Access Compliance Report

Public Rights-of-Way

(Curb Ramps)

Main Street: Foothill_BlvD Cross Street: GIGI_DR Location: N

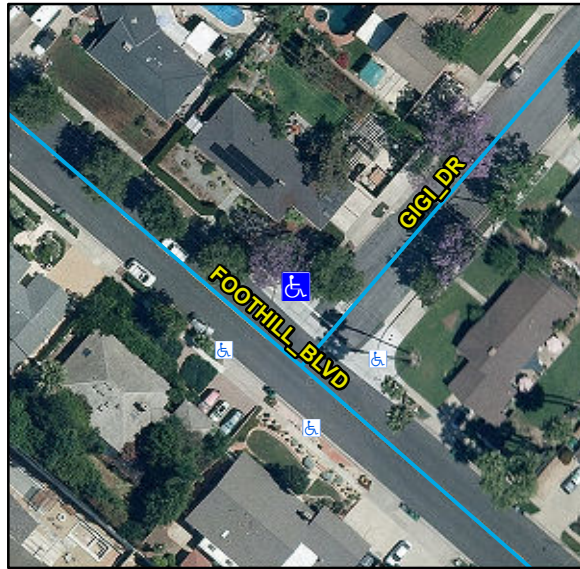
N/A	Ramp Inside Crosswalk 1	N/A	Yes	Ramp Inside Crosswalk 2	N/A
	Crossing 1 Slope (%)	3.1		Crossing 2 Slope (%)	2.9
	Crossing 1 Cross Slope (%)	1.2		Crossing 2 Cross Slope (%)	0.6
Yes	Gutter Ponding	No	No	Curb Slope	6.5
Yes	Gutter Lip Height (in)	0		Road Run Slope (%)	1.1
Yes	Gutter Run Slope (%)	1.3		Road Cross Slope (%)	1.6
Yes	Gutter Cross Slope (%)	0.8			
Yes	Overall Surface Condition: Acceptable		Yes	Perp Joint Present	Yes
	Cross Gutter Present?	Yes		Spandrel Present?	Yes
	Replace Cross Gutter?	No		Replace Spandrel?	No

Remove & Replace Curb Slope.

R304.2.2, STD 1115
